Building Conservation comments

File Ref: 25/00018/FP

Address: 23a Hitchin Street, Baldock, Hertfordshire SG7 6AQ

Subject: Change of use from a funeral parlour - E(c)(ii), to 4 number dwellinghouses - C3(a) and associated single storey extensions. Removal of existing entrance portal and installation of new privacy gates following demolition of existing car port roof structures.

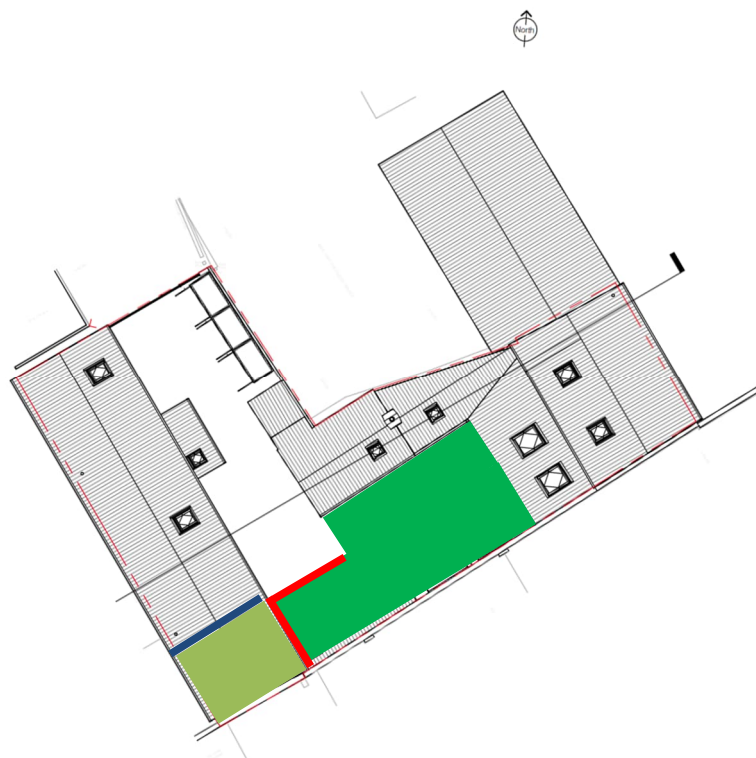
- 2.1 The application site is located in the Baldock Conservation Area, to the south of Hitchin Street with access between two grade II listed buildings: the White Hart PH to the north-east and Lyme Cottage to the south-west. OS map regression shows that various buildings have occupied this backland site since at least from the late C19.
